## **Appendix C: Written Comments Received on the DEIS**

**Resolution on a ULURP application by BP 343 Madison Associates LLC and the MTA for two Vanderbilt Corridor special permits (ZR 81-633 and 81-634) to redevelop 341-347 Madison Ave**

**Recommendation on ULURP Application Nos. C210369ZSM and C210370ZSM  
343 Madison Avenue – Metropolitan Transportation Authority Headquarters  
By Boston Properties and the Metropolitan Transportation Authority**

**TESTIMONY TO THE NEW YORK CITY PLANNING COMMISSION REGARDING  
343 MADISON AVE, CEQR #21DCP020M**

#### Other Measure to Improve Traffic Flow and Pedestrian Safety for Consideration in the FEIS

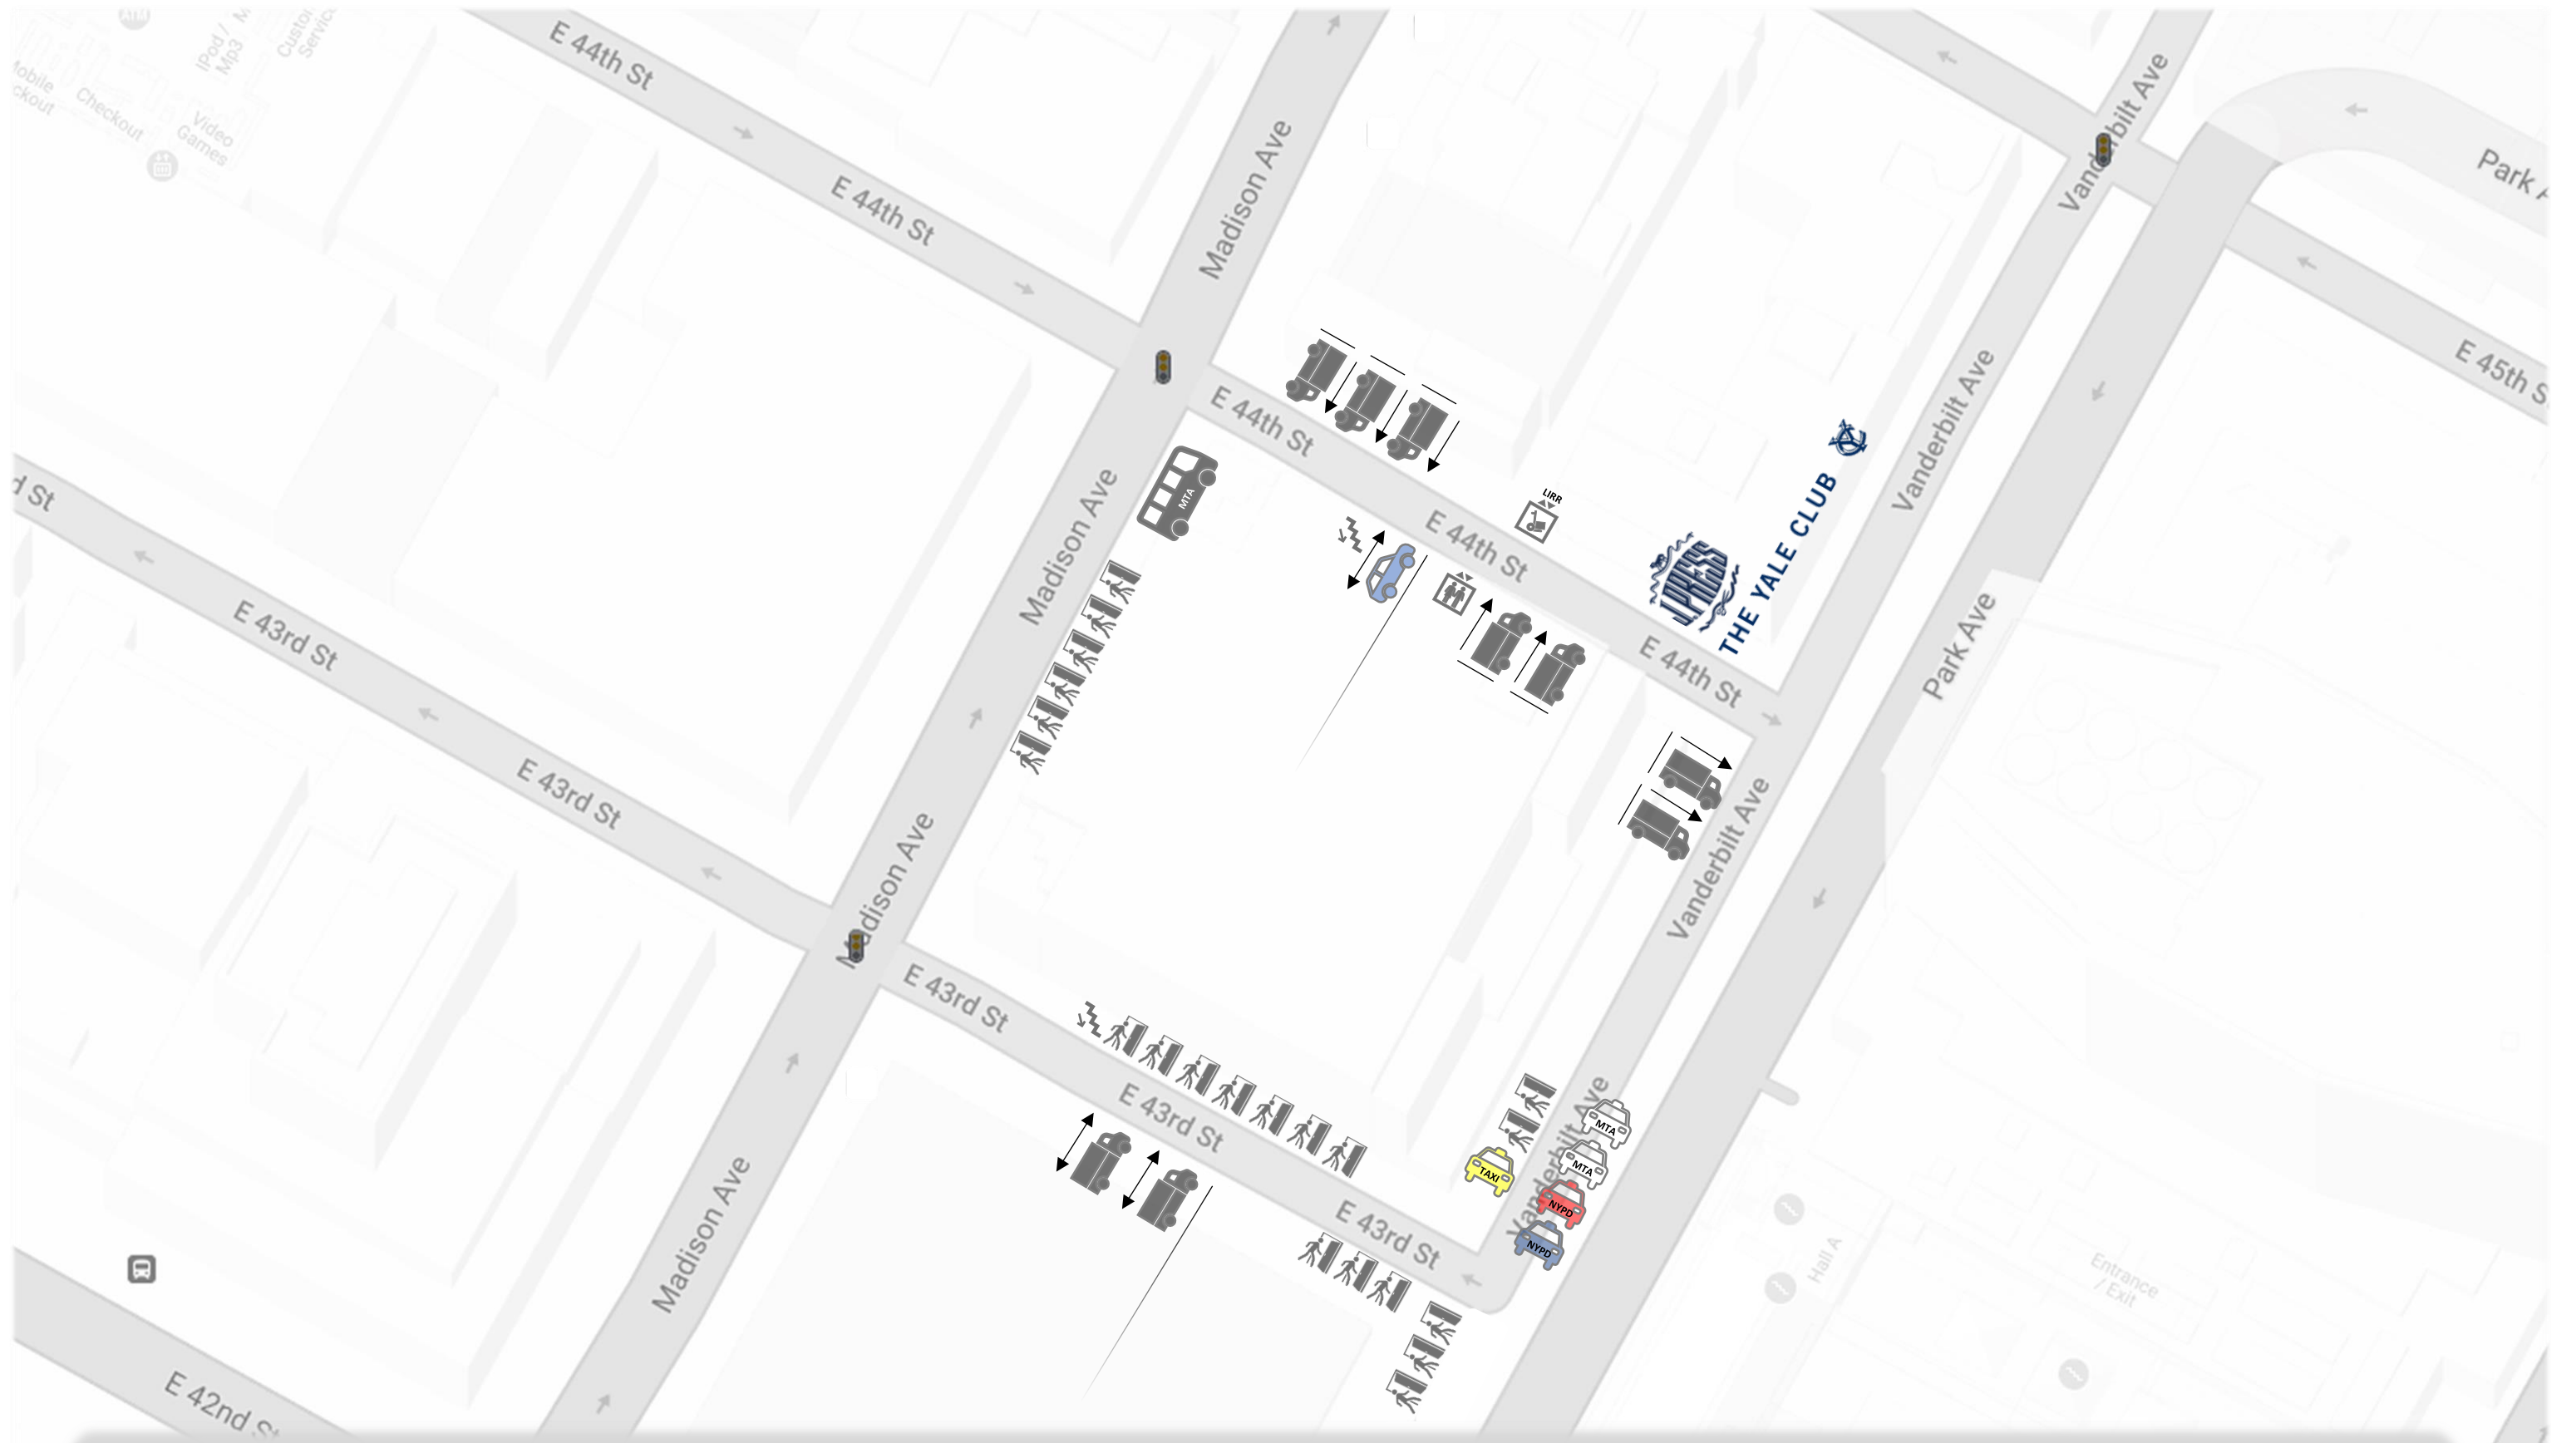
A number of other operational and design changes should be analyzed for incorporation in order to provide the necessary mitigation:

- (1) Move the northern pedestrian crossings at the intersections of Madison Avenue and 43rd 44th and 45th Streets approximately 50 feet into the block to provide the necessary vehicular storage capacity while at the same time pedestrians could safely cross.
- (2) Operate the 44th and 45th intersections utilizing a 3 phase sequence
- (3) Reintroduce the Barnes' Dance at the intersections of Madison Avenue and 44th and 45th Streets. Consider a common three phase operation and test it with different cycles, 120s, and 150s. (*Please refer to the attached sketch*).
